AD 50-25-01

Airworthiness Directives; STINSON Model All Model 108 Series Aircraft

50-25-01 STINSON: Applies to All Model 108 Series Aircraft.

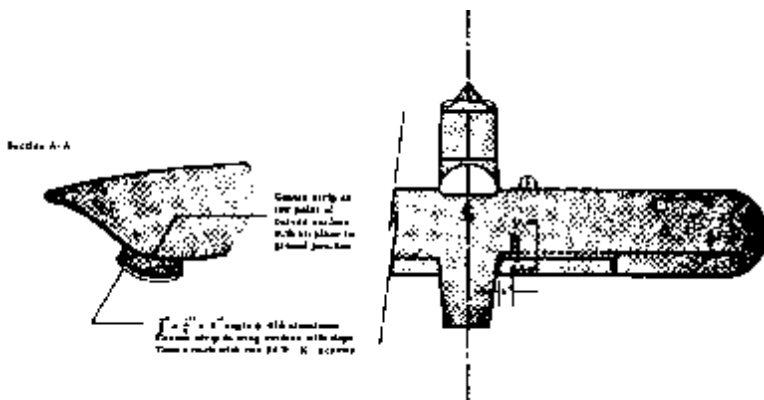
Reports have been received of fuel seepage into the space between the inner cabin trim and the outer fabric covering of the fuselage. This results in soaking of insulating material in the cabin wall.

The source of the fuel can be spillage during filling of tanks, thermal expansion of fuel in full tanks, or tank leakage. This fuel runs to the under surface of the wing, adhering to the lower curved surface of the trailing edge of the wing at the flap well, thence inboard to the fuselage and across the rear window. Since the window seal is often not perfectly tight the fuel may then enter the cabin wall.

To preclude the fire hazard of fuel soaked insulation within the cabin wall due to these causes, a drip strip similar to that shown in Figure 1 should be installed on the underside of each wing. This drip strip will prevent fuel from flowing from the wing to the fuselage.
